Change No. 15  
Licenses Nos. DPR-32  
and DPR-37

CHANGE NO. 15 TO THE TECHNICAL SPECIFICATIONS

VIRGINIA ELECTRIC & POWER COMPANY

DOCKET NOS. 50-280 AND 50-281

Figure 2.1-1 Reactor Core Thermal & Hydraulic Safety Limits - Three Loop Operation, 100% Flow

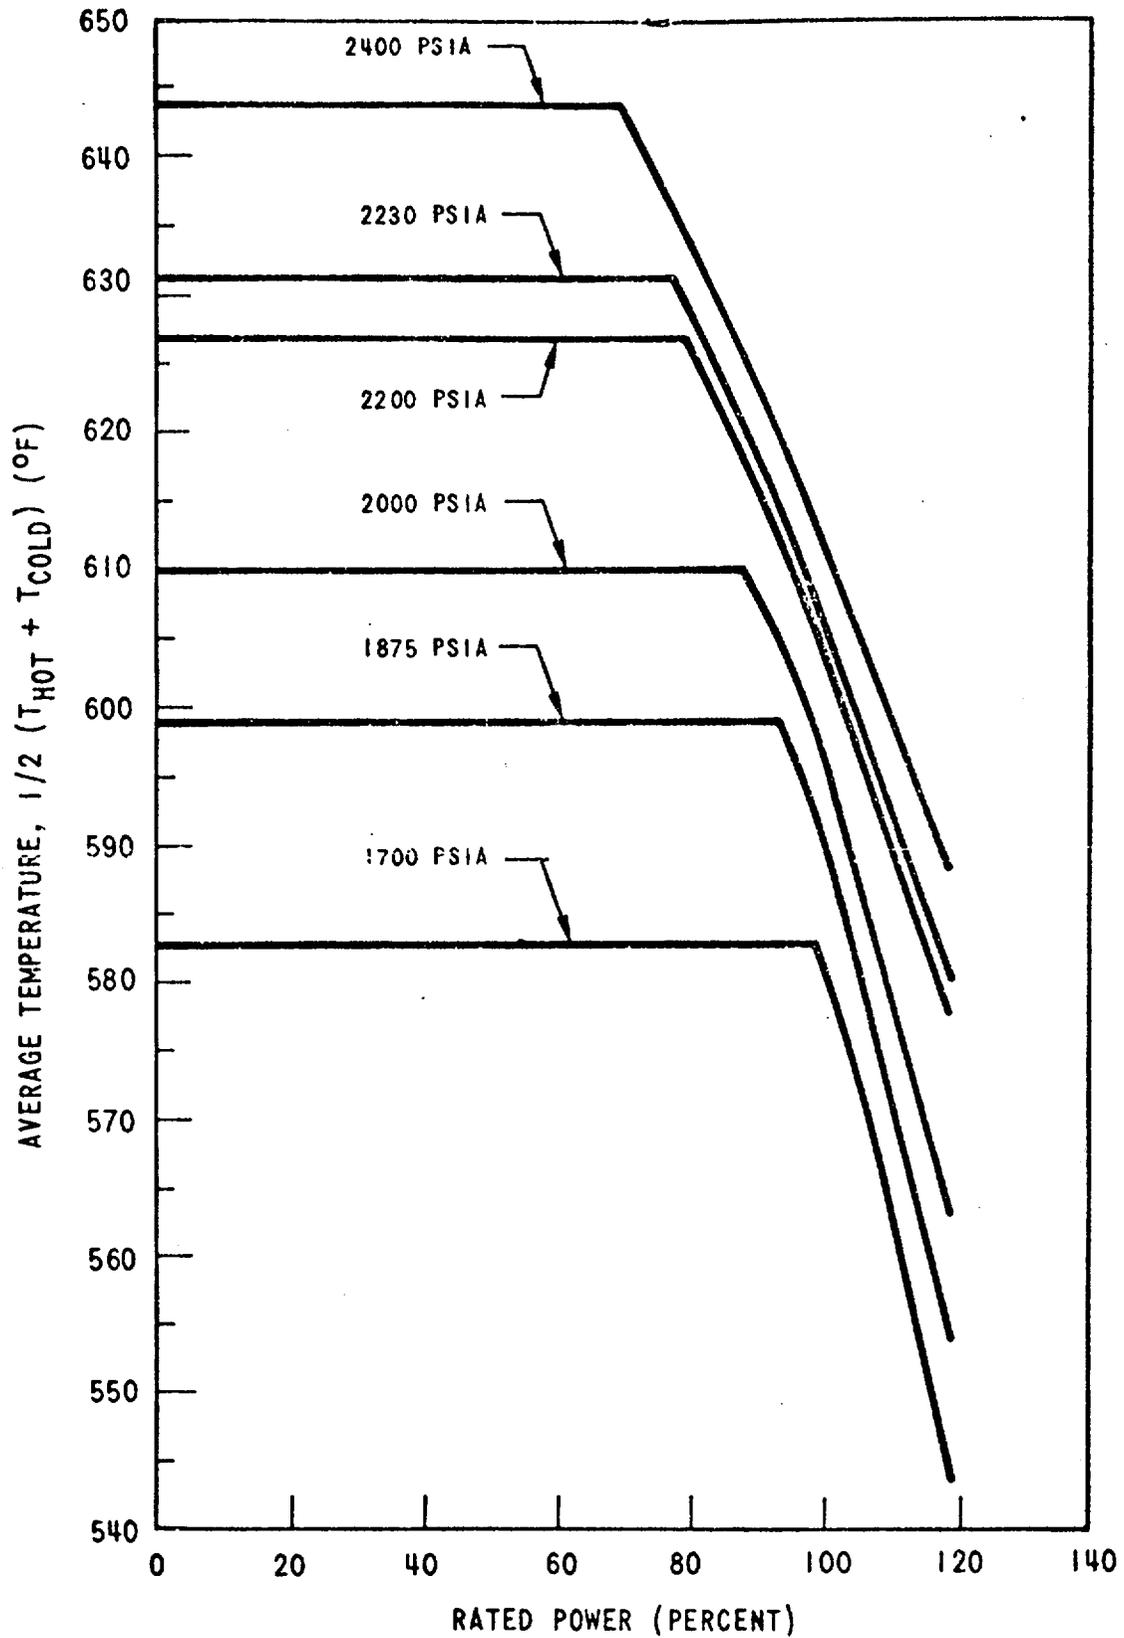
The curves of TS Figure 2.1-1 which show the allowable power level decreasing with increasing temperature at selected pressures for constant flow (three loop operation) represent the loci of points of thermal power, coolant system average temperature, and coolant system pressure for which the DNB ratio is not less than 1.30. The area where clad integrity is assured is below these lines. In order to completely specify limits at all power levels, arbitrary constant upper limits of average temperature are shown for each pressure at powers lower than approximately 75% of rated power. The temperature limits at low power are considerably more conservative than would be required if they were based upon a minimum DNB ratio of 1.30 but are such that the plant conditions required to violate the limits are precluded by the self actuated safety valves on the steam generators. The three loop operation safety limit curve has been revised to allow for heat flux peaking effects due to fuel densification.

TS Figures 2.1-1, 2, and 3 are based on a  $F_{\Delta H}^N$  of 1.55, a 1.55 cosine axial flux shape and a DNB analysis as described in Section 4.3 of the report Fuel Densification Surry Power Station, Unit 1 dated December 6, 1972 (including the effects of fuel densification). They also include an allowance for an increase in the enthalpy rise hot channel factor based on the expression:

Figure 2.1-2. Reactor Core Thermal and Hydraulic Safety Limits, Two Loop Operation, Loop Stop Valves Open

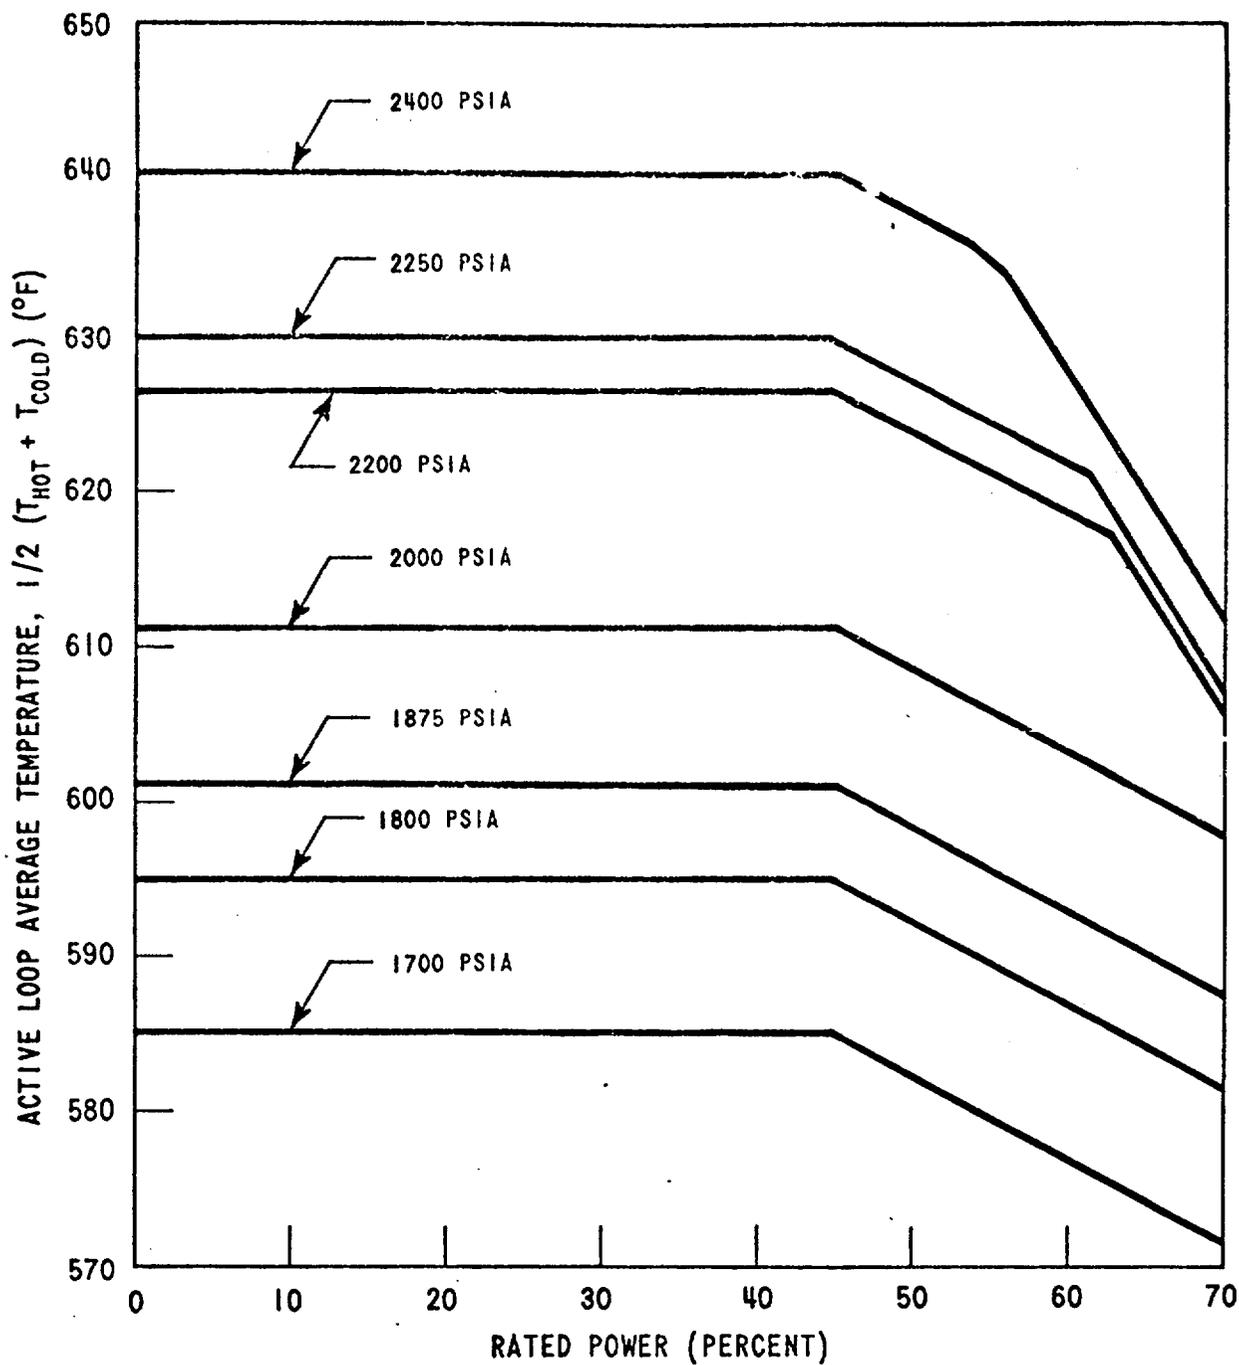
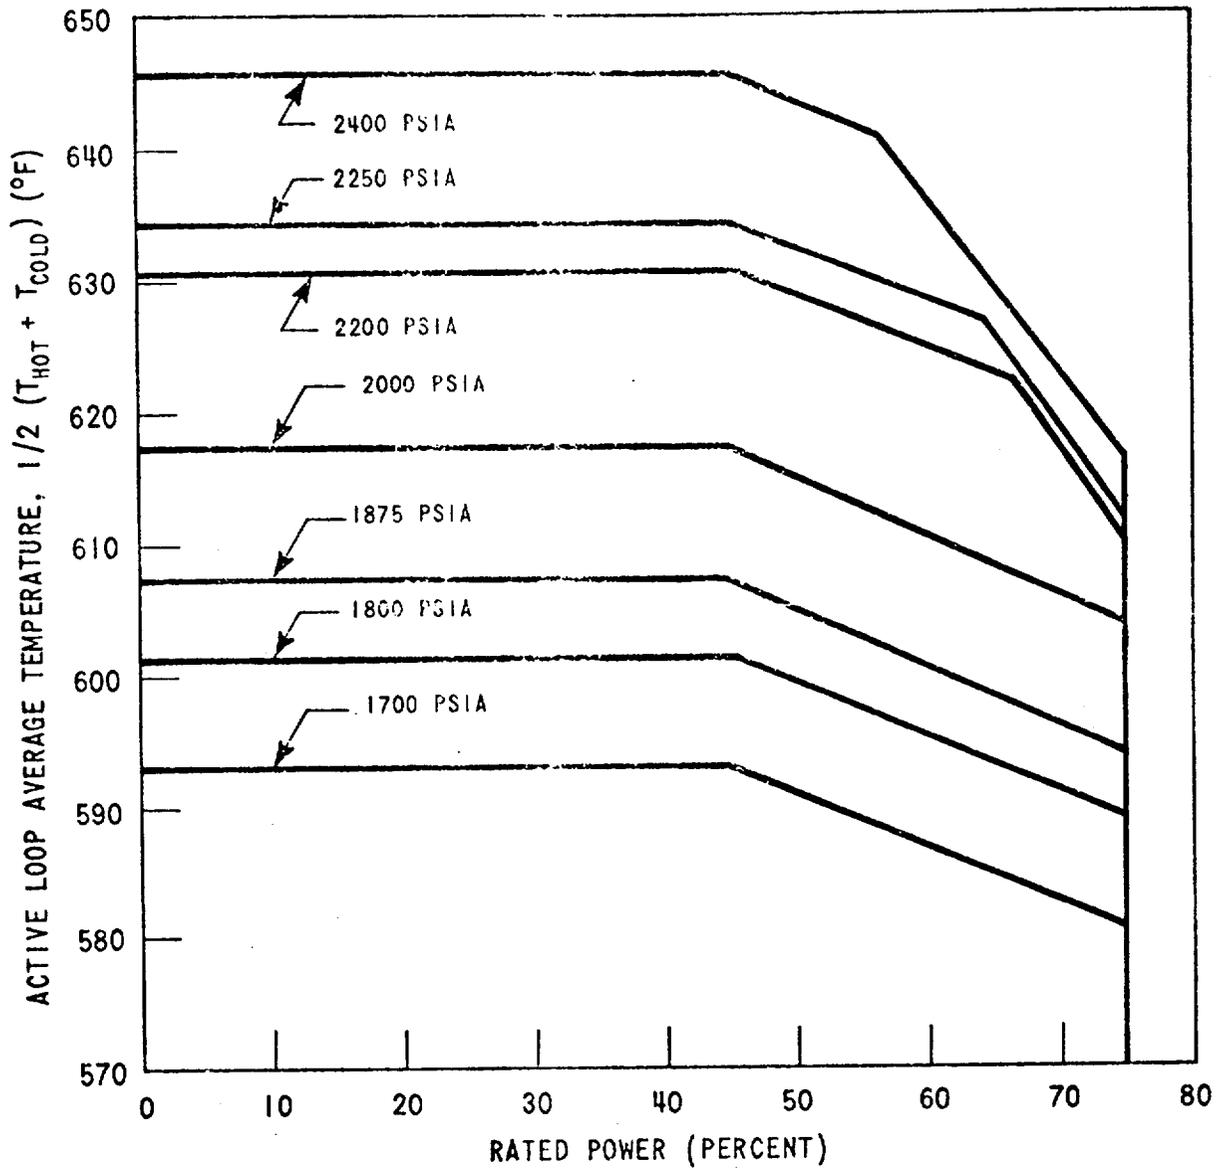
The curves of TS Figures 2.1-2 and 2.1-3, which show the allowable power level decreasing with increasing temperature at selected pressures for constant flow (two loop operation), represent the loci of points of thermal power, coolant system average temperature, and coolant system pressure for which either the DNB ratio is equal to 1.30 or the average enthalpy at the exit of the core is equal to the saturation value. At low pressures or high temperatures the average enthalpy at the exit of the core reaches saturation before the DNB ratio reaches 1.30 and, thus, this arbitrary limit is conservative with respect to maintaining clad integrity. In order to completely specify limits at all

power levels, arbitrary constant upper limits of average temperatures are shown for each pressure at powers lower than approximately 45% of rated power. The limits at low power as well as the limits based on the average enthalpy at the exit of the core are considerably more conservative than would be required if they were based upon a minimum DNB ratio of 1.30. The plant conditions required to violate these limits are precluded by the protection system and the self actuated safety valves on the steam generator. Upper limits of 70% power for loop stop valves open and 75% with loop stop valves closed are shown to completely bound the area where clad integrity is assured. These latter limits are arbitrary but cannot be reached due to the Permissive 8 protection system setpoint which will trip the reactor on high nuclear flux when only two reactor coolant pumps are in service. TS Figures 2.1-2 and 2.1-3 have not been revised as these have been found to be adequate and conservative even including the heat flux peaking effects due to fuel densification. .

FIGURE 2.3-1

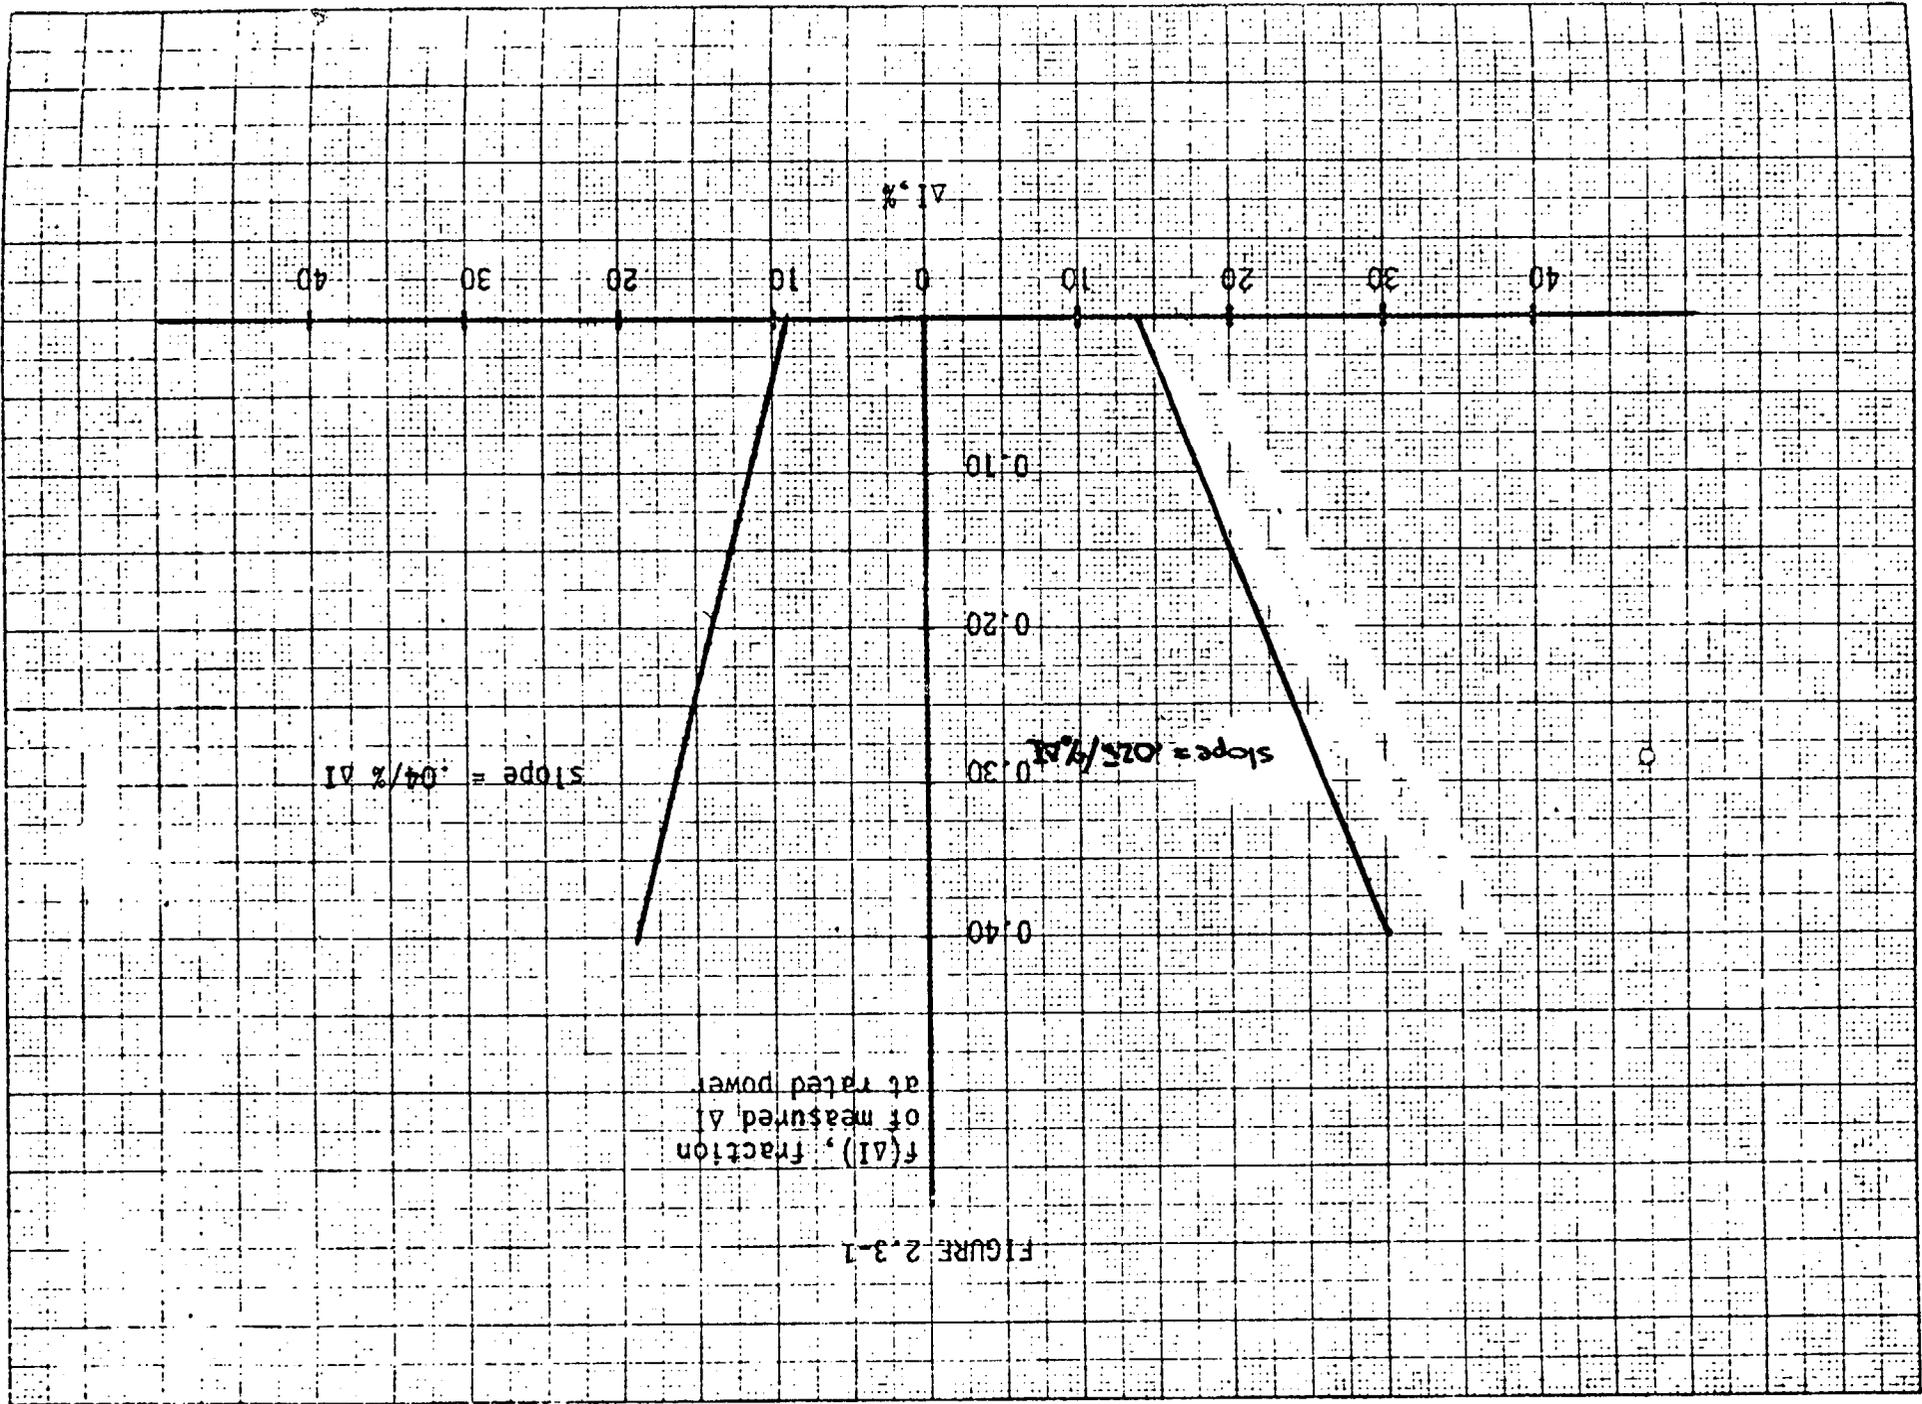
$f(\Delta I)$  = function of  $\Delta I$ , percent of rated core power as shown in Figure 2.3-1
